THE ANNEX

APARTMENT COMMUNITY

SITE PLAN FOR PLANNING COMMISSION

Administrative Amendment Narrative

THE ANNEX
AMENDMENT FOR PLANNING COMMISSION
DIMENSIONAL SITE PLAN (NORTH)

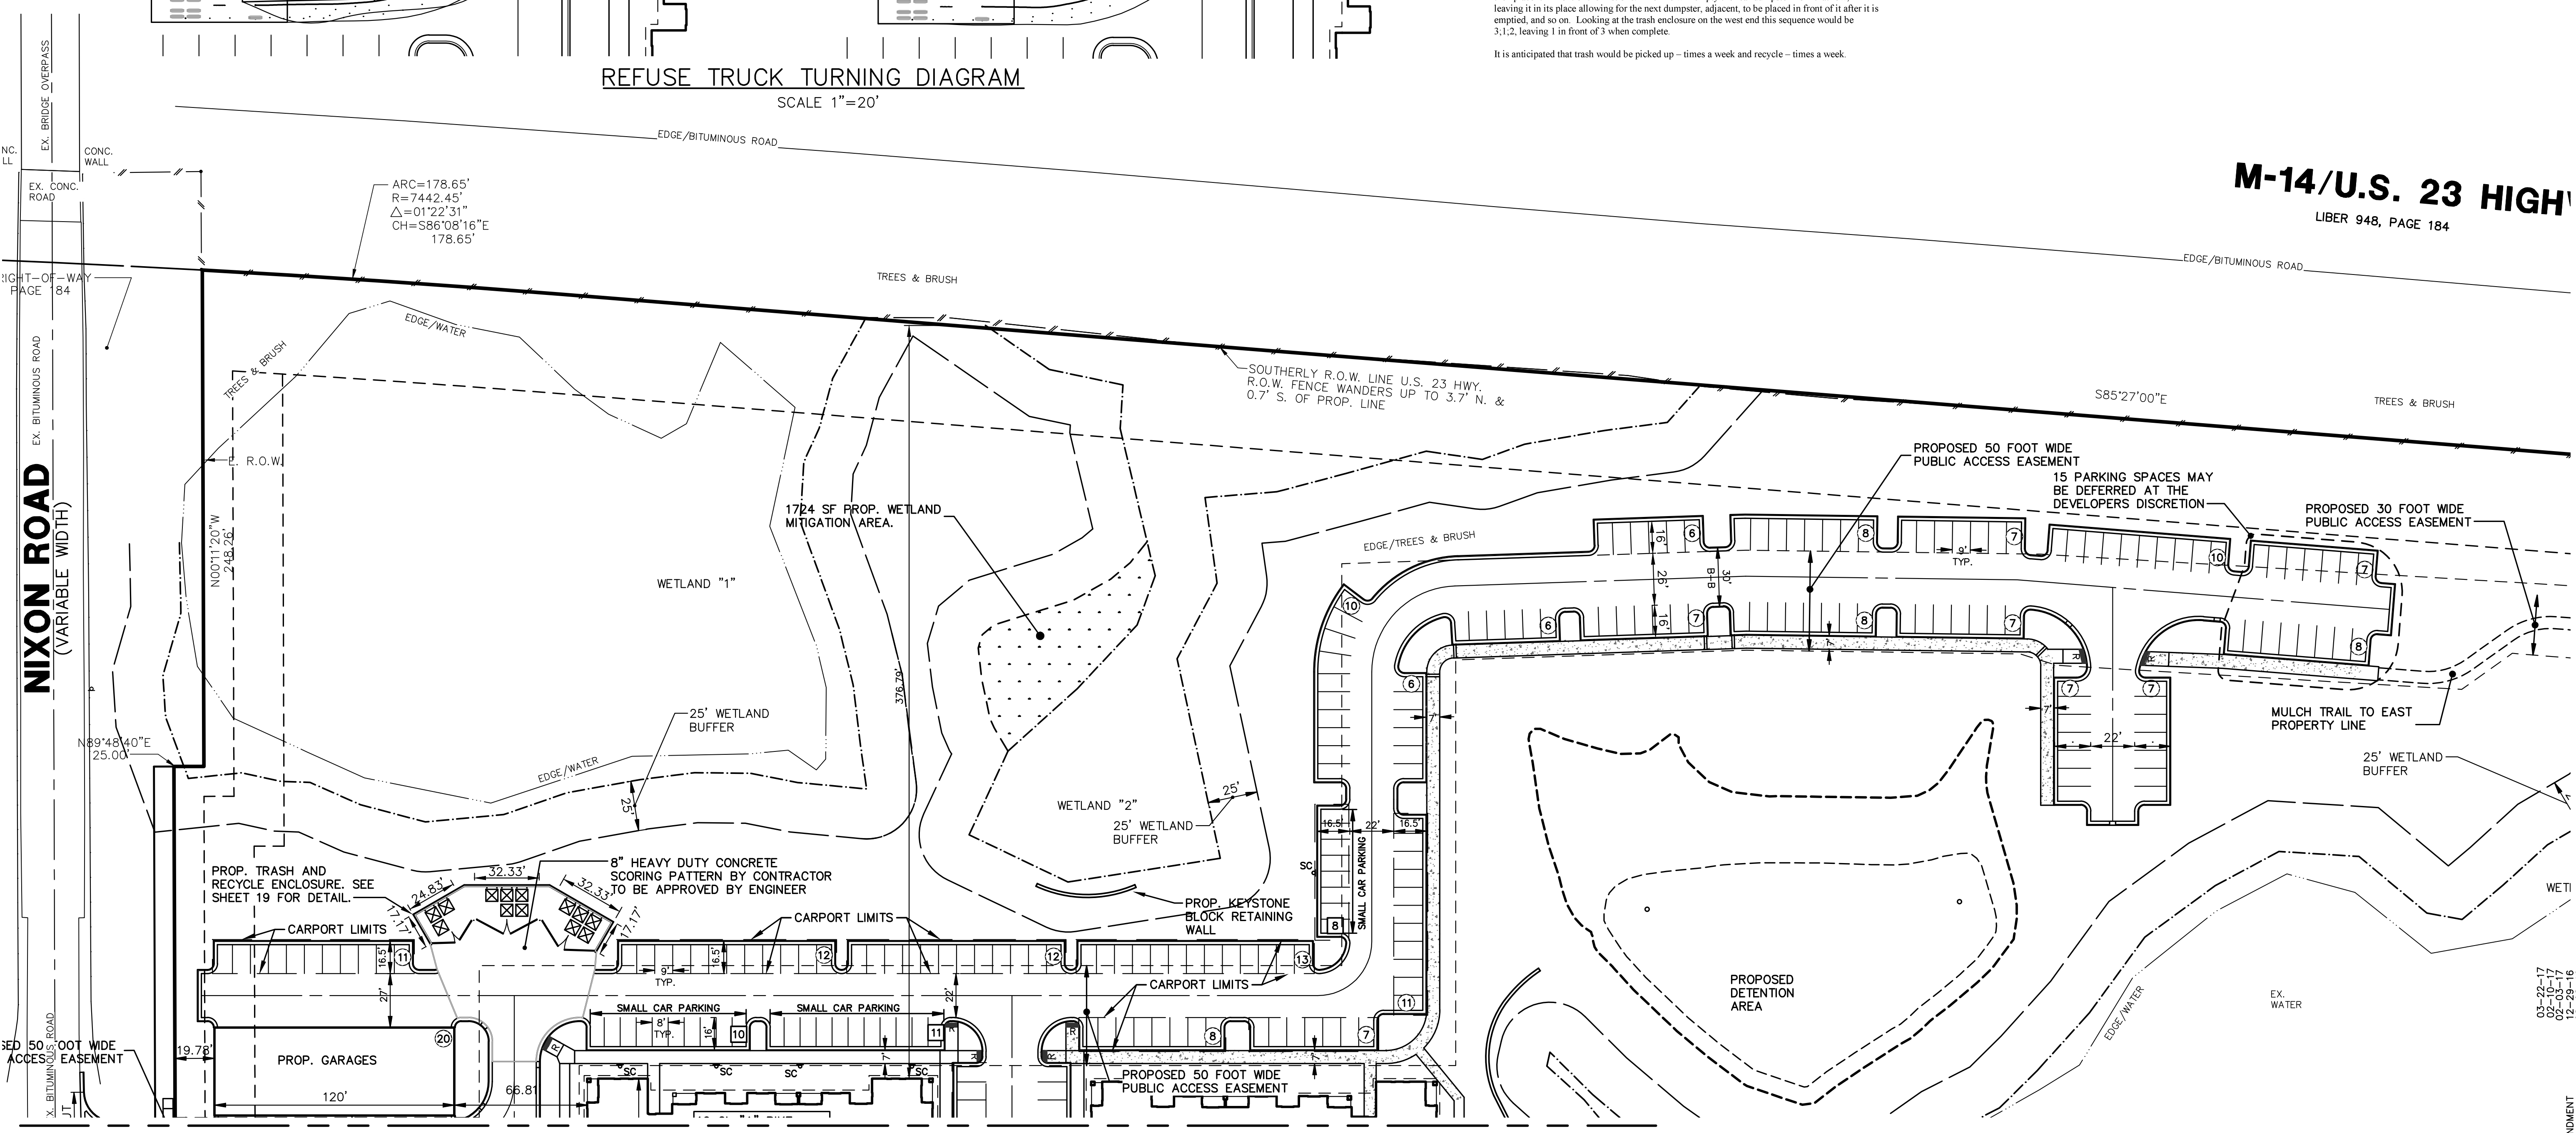
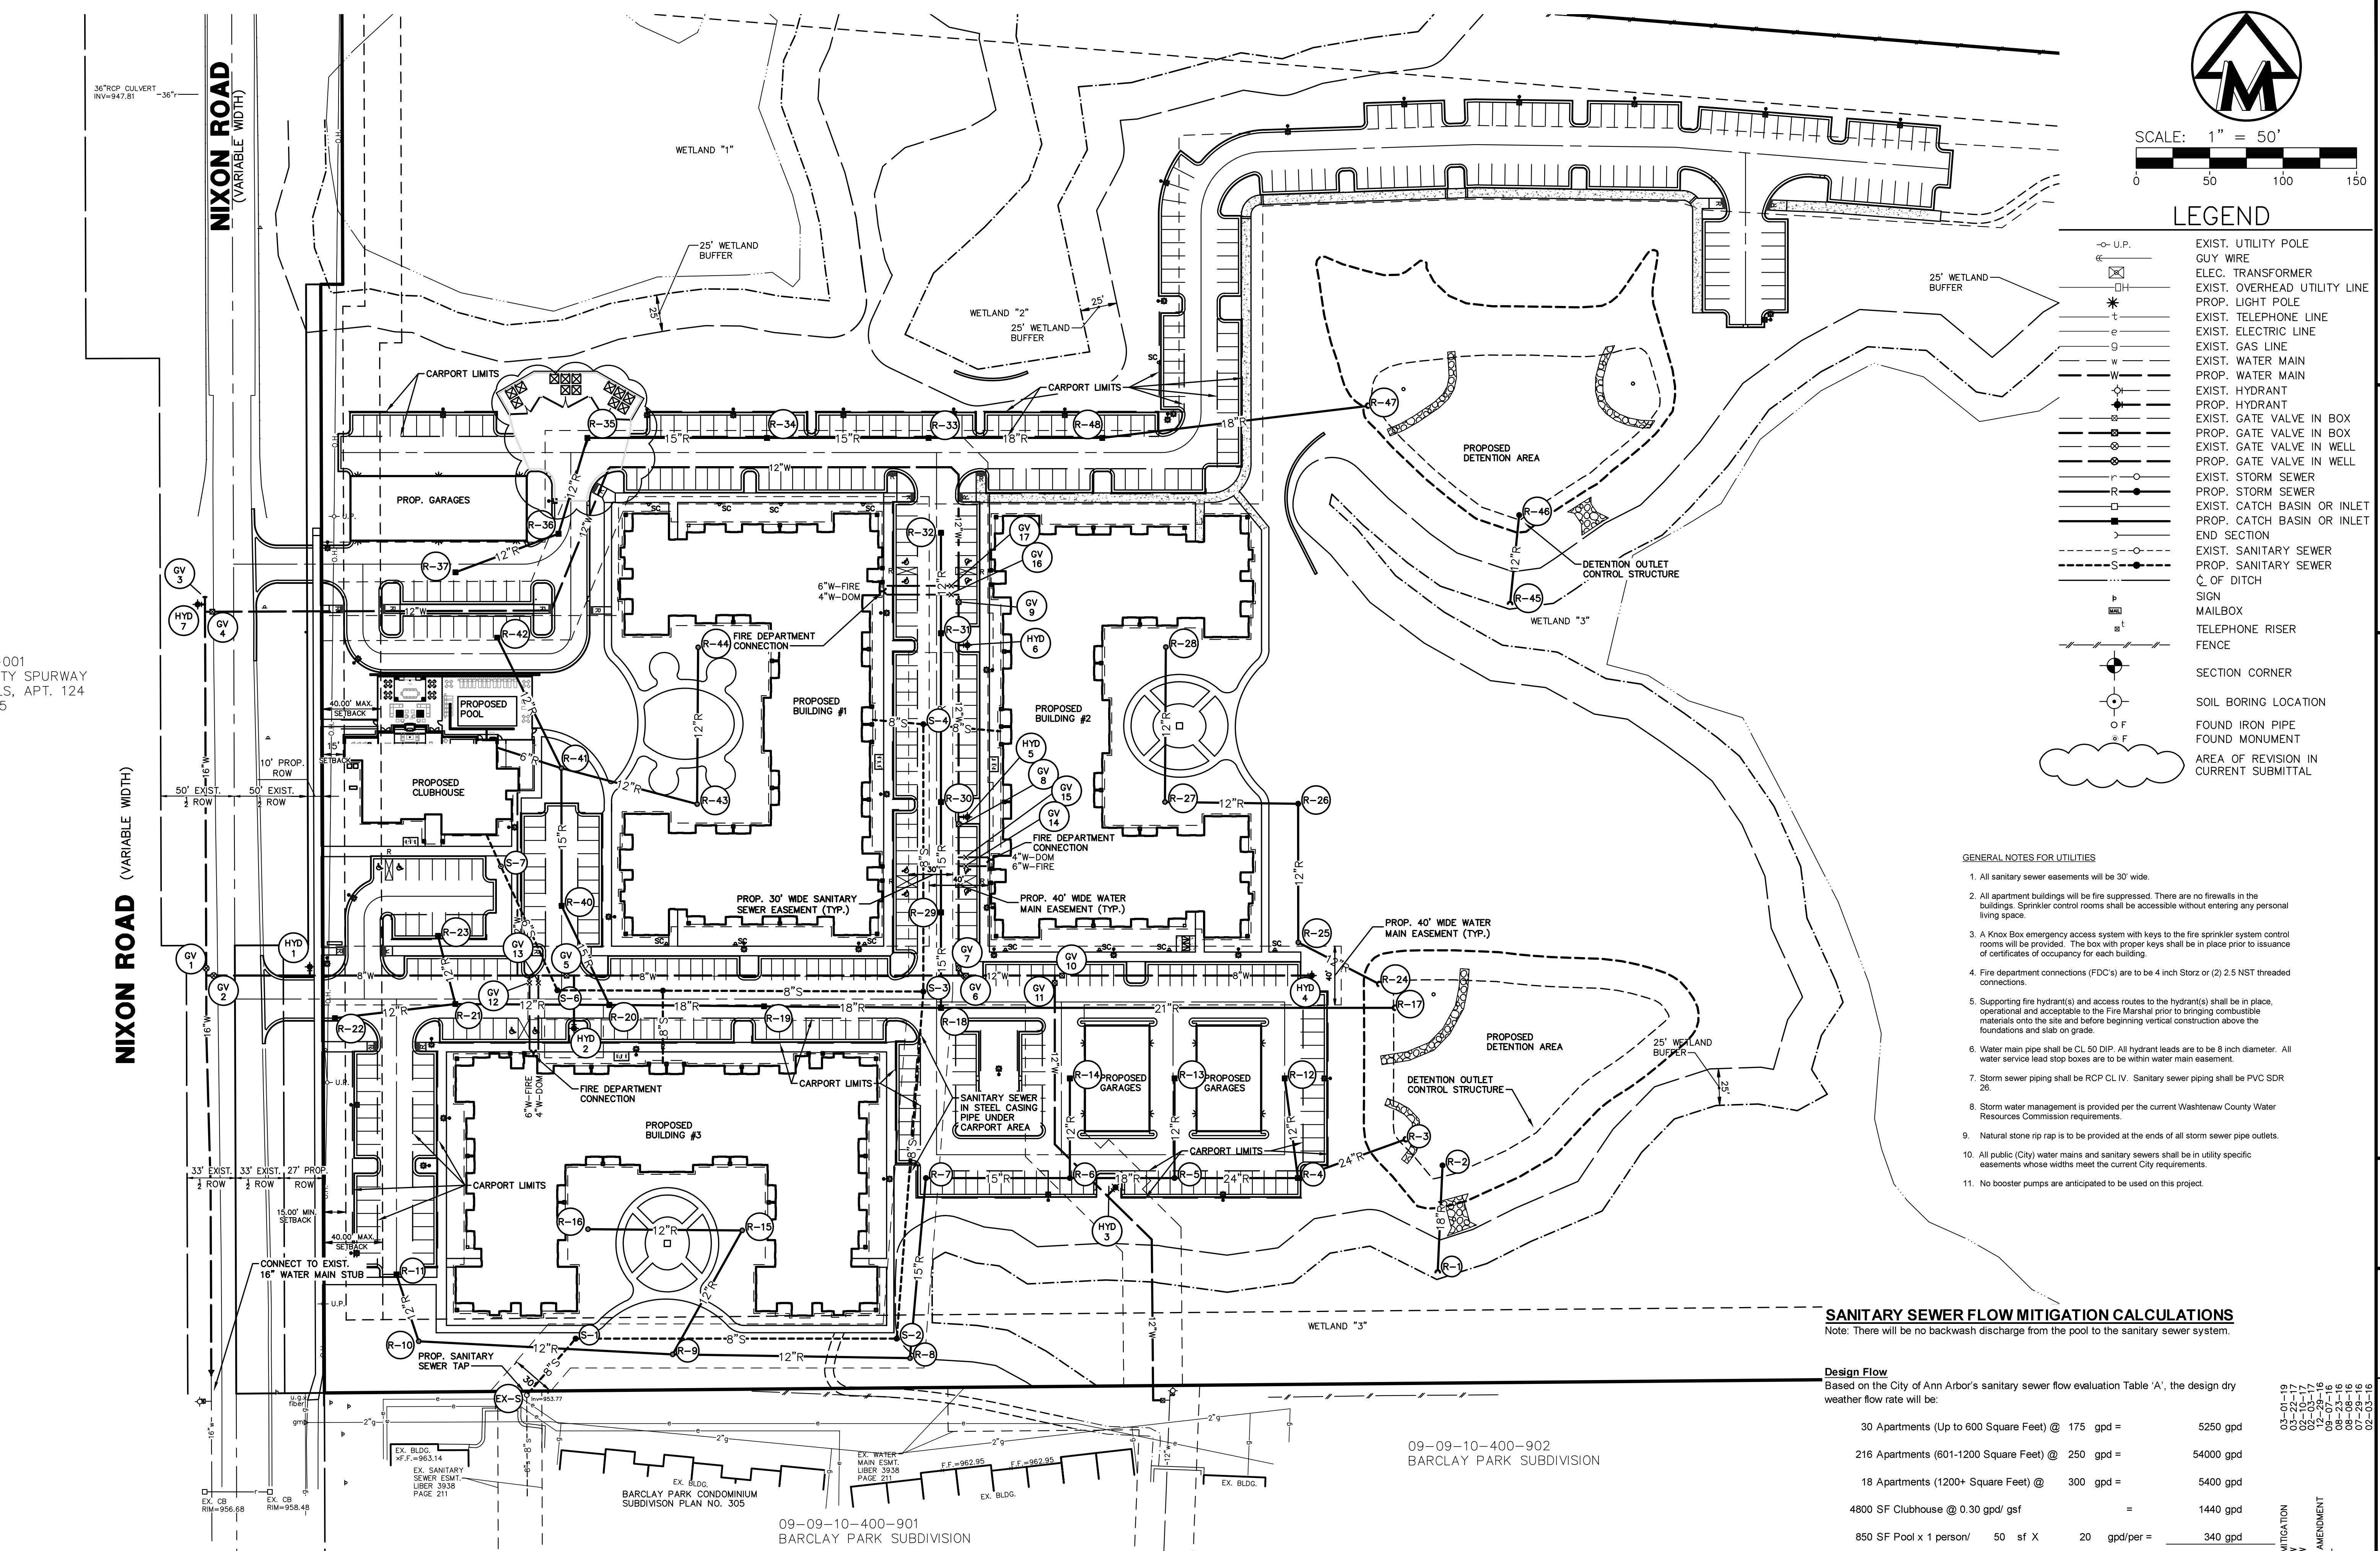
Sheets 5 & 6: The changes in the building configuration has been reflected on the overall site layout. Site dimensions have been updated as well as the site data analysis. Bike parking has been reconfigured based on the elimination of the fourth building. Sidewalk serving the buildings have been revised due to door locations on new buildings as well as barrier free parking spaces.

THE ANNEX
 AMENDMENT FOR PLANNING COMMISSION
 UTILITY PLAN

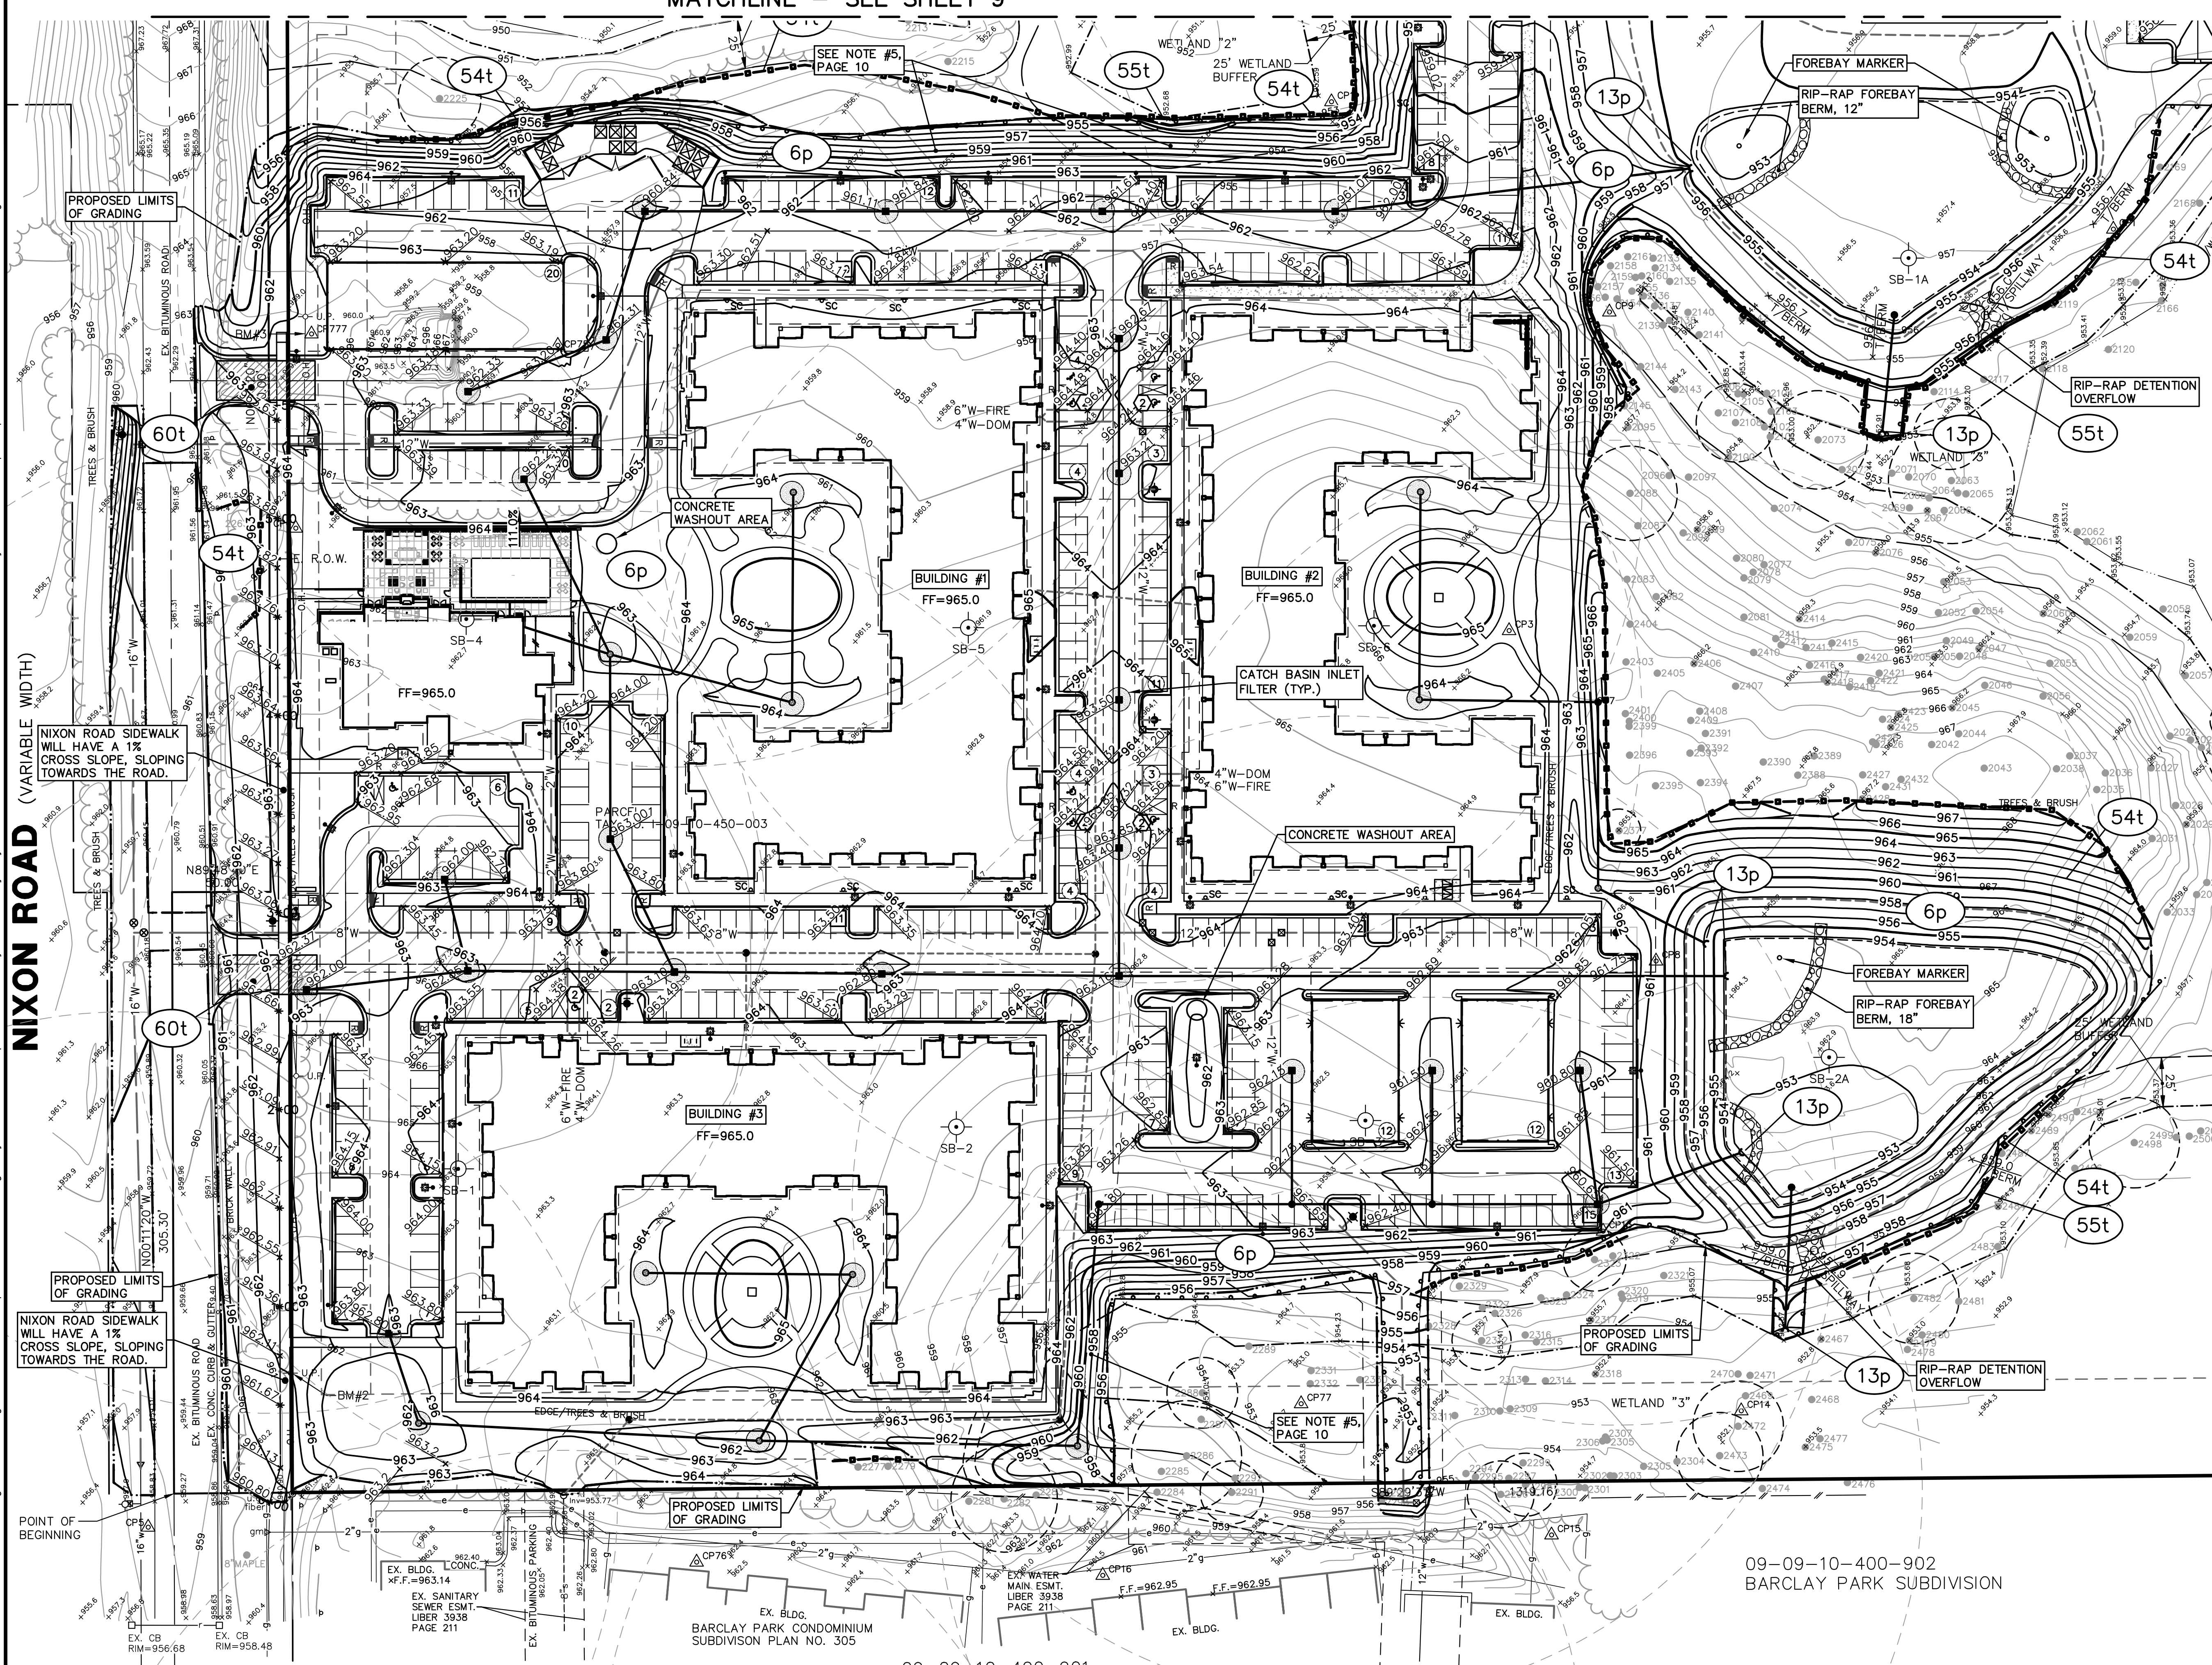
Sheet 7: Utilities servicing the fourth building on the previous site plan have been eliminated. The water main loop around the east side of building 2 has been eliminated as it was no longer needed to service the fourth building.
